# Work Order ID 90329

Item Name: Energy Attenuating Floor Provisions

# DART SERVICE INSTRUCTION

TO AMEND INSTALLATION INSTRUCTIONS IIN-D350-689 REV. B  
AND INSTRUCTIONS FOR CONTINUED AIRWORTHINESS ICA-D350-689 REV. 1

**FIGURE 1: UPDATES TO FIGURE 21 (IIN-D350-689) AND 25-21 (ICA-D350-689)**  
 With reference to Figures 19 and 20 of IIN-D350-689  
 (Figures 25-19 and 25-20 of ICA-D350-689)

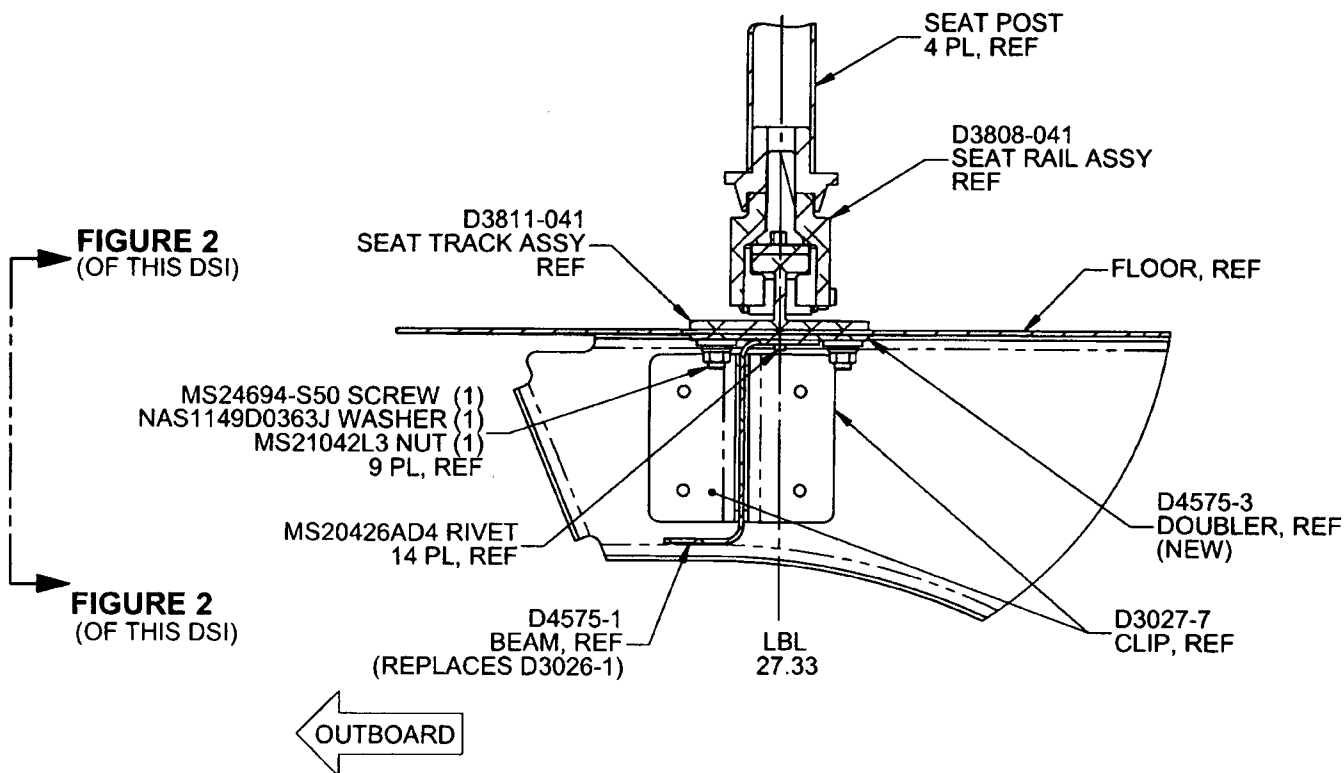
If there is an existing stringer at LBL 27.33, it will need to be removed from that location. Locate D4575-1 Beam and D4575-3 Doubler as shown in Figure 1 of this Service Instruction. Transfer drill existing holes from the aircraft floor to the D4575-1 Beam and D4575-3 Doubler. Ensure 1.0" to 1.5" rivet pitch and add additional holes if required. If there is no existing stringer, locate D4575-1 Beam and D4575-3 Doubler as shown in Figure 1 of this Service Instruction and drill Ø0.128" holes on a 1.0" to 1.5" pitch.

If there is an existing stringer at LBL 27.33, it will need to be removed from that location. Locate D3026-1 Channel as shown in Figure 4 and transfer existing holes from the aircraft floor to the D3026-1 Channel. Ensure 1.0" to 1.5" rivet pitch and add additional holes if required. If there is no existing stringer, locate D3026-1 Channel as shown in Figure 4 and drill Ø0.128" holes on a 1.0" to 1.5" pitch.

**FIGURE 2: RELIEFS ON D4575-1/-3**  
(ONLY D4575-1/-3 SHOWN FOR CLARITY)  
VIEW LOOKING INBOARD

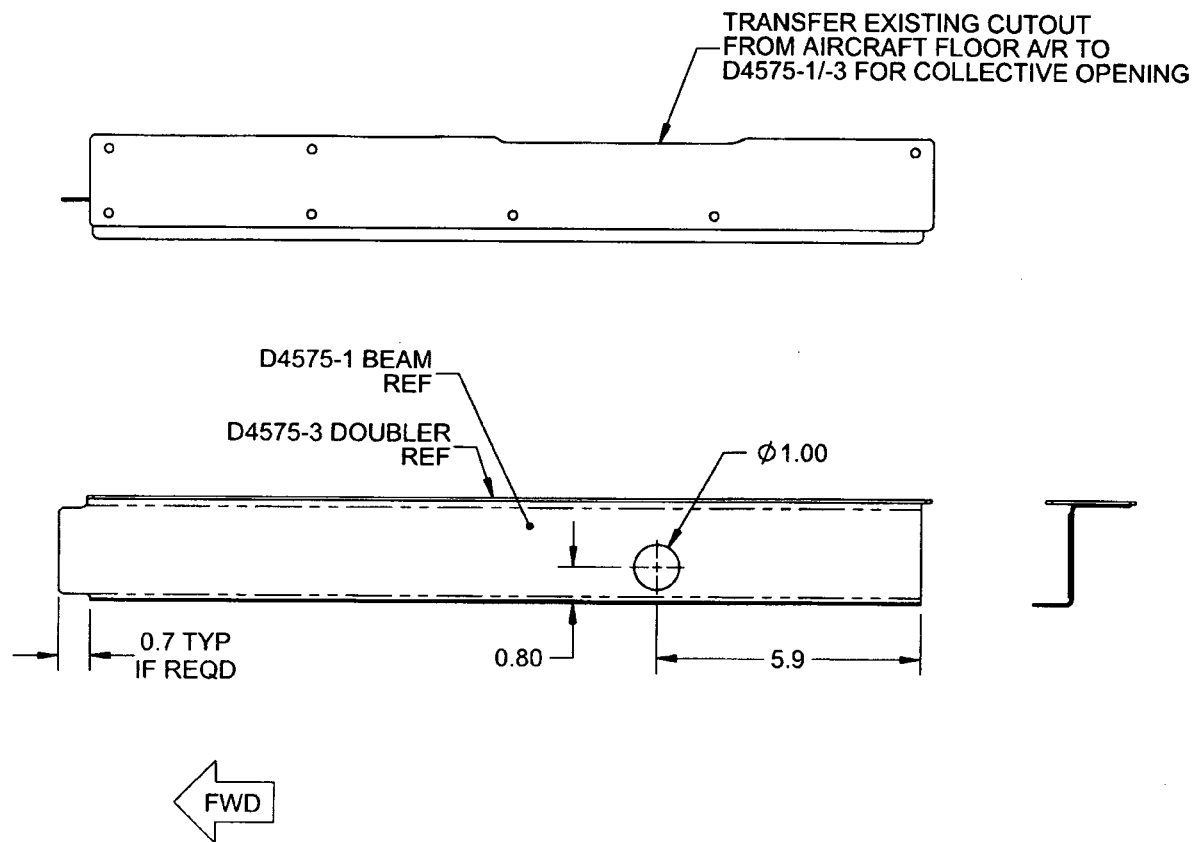
**Note:** Drill a Ø1.00" (Ø25.4 mm) hole in the D4575-1 Beam to clear extension tube of collective and cutout as required for clearance of collective opening and fwd bulkhead as shown in Figure 2 of this Service Instruction.
